INDIANA DEPARTMENT OF TRANSPORTATION

MEMORANDUM

RE: Agenda for the March 17, 2005 Standards Committee Meeting

REVISION TO 2006 STANDARD SPECIFICATIONS

809-ITS-03

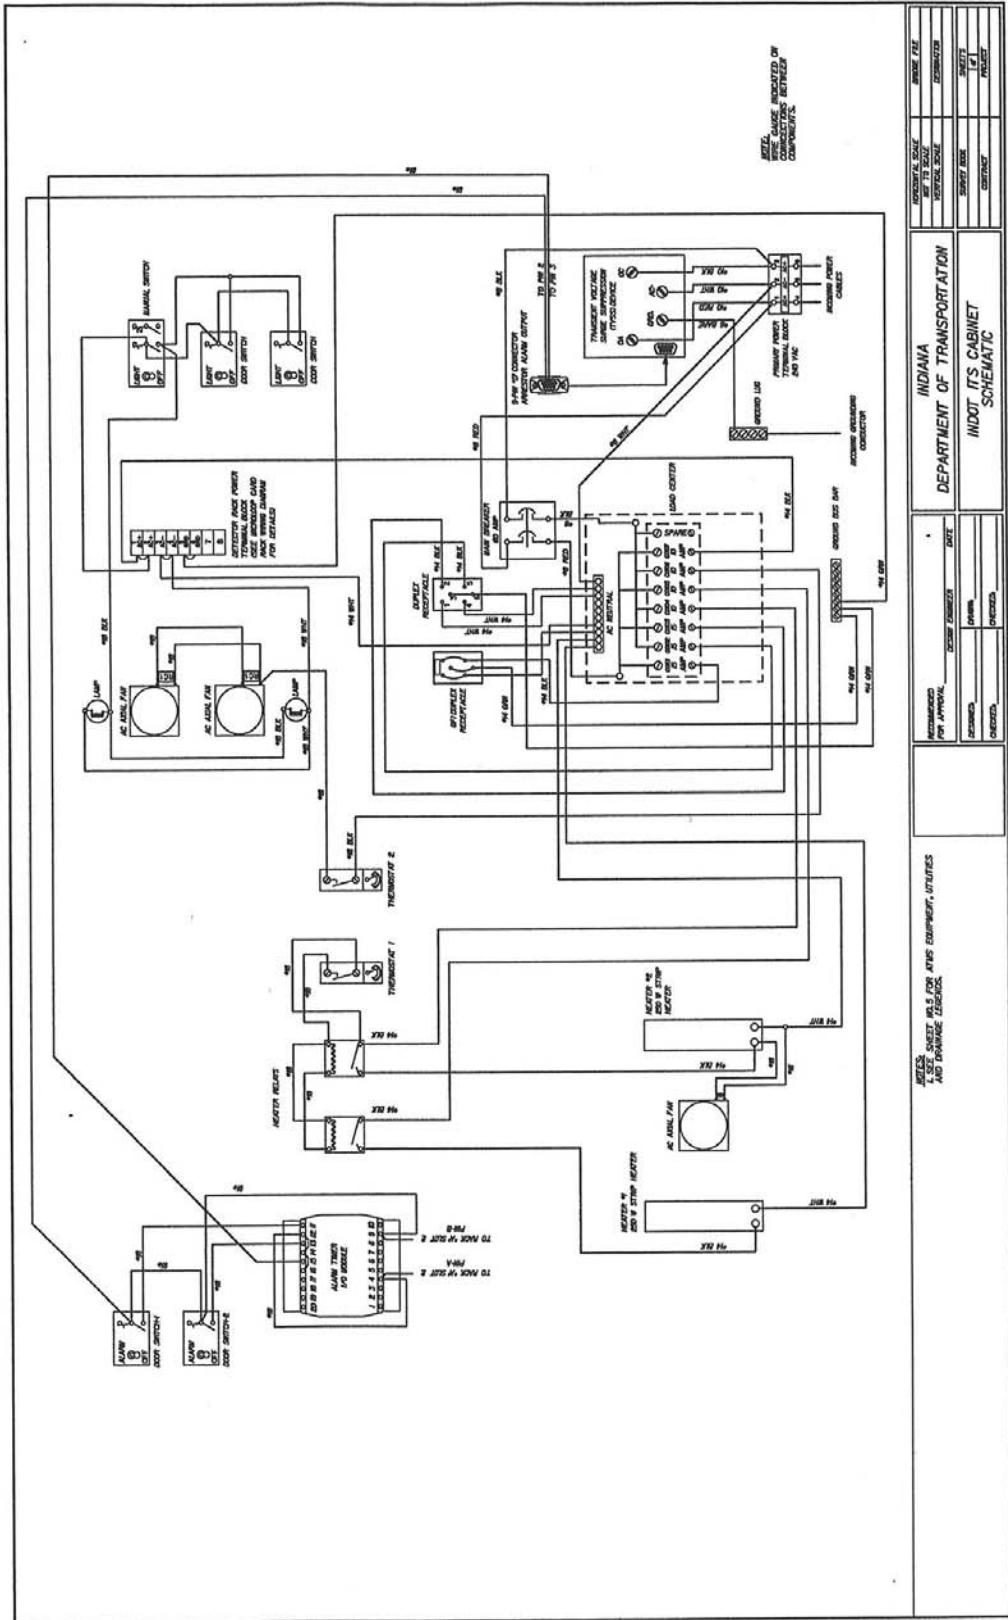
REVISION TO STANDARD DRAWINGS

809-ITSC-01 ITS Cabinet Detail
809-ITSC-02 Cabinet Layout Details
809-ITSC-03 Cabinet Punch Out Details
809-ITSC-04 Cabinet Schematic
809-ITSC-05 Detector Card Rack Detail
809-ITSC-06 ITS Cabinet Microloop Card Rack Wiring Diagram
809-ITSC-07 Engraved Tag Detail

809-ITSC-07

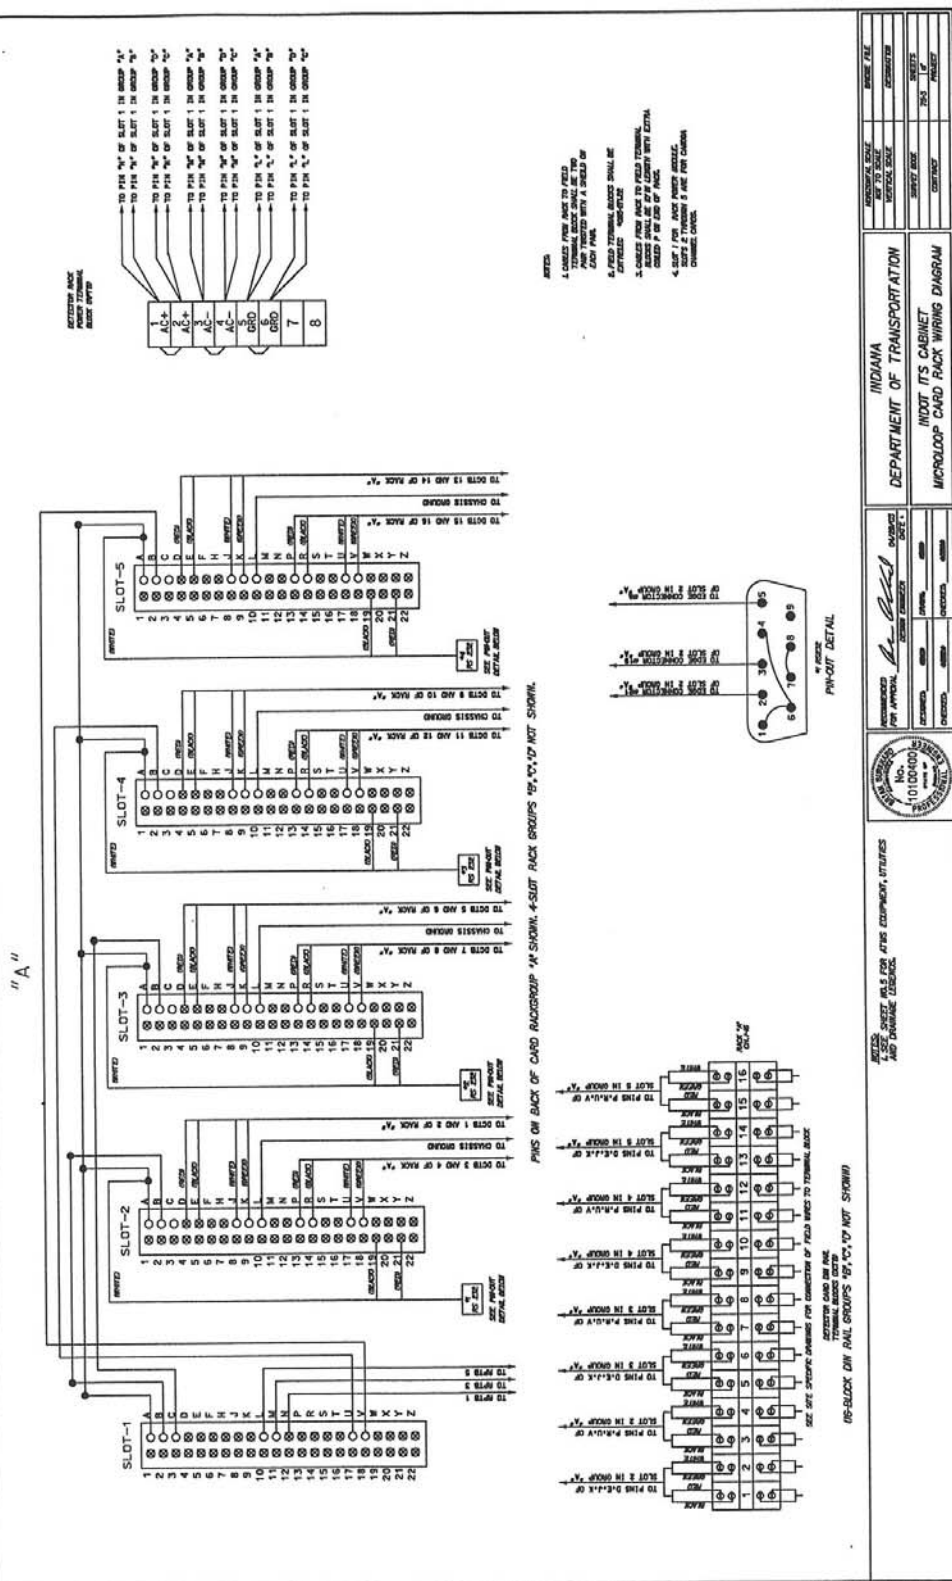
Above tags are one each for a total of 4 tags.
RACK A, RACK B, RACK C, and RACK D

HEATER 1 and HEATER 2 are 1 tag Each.
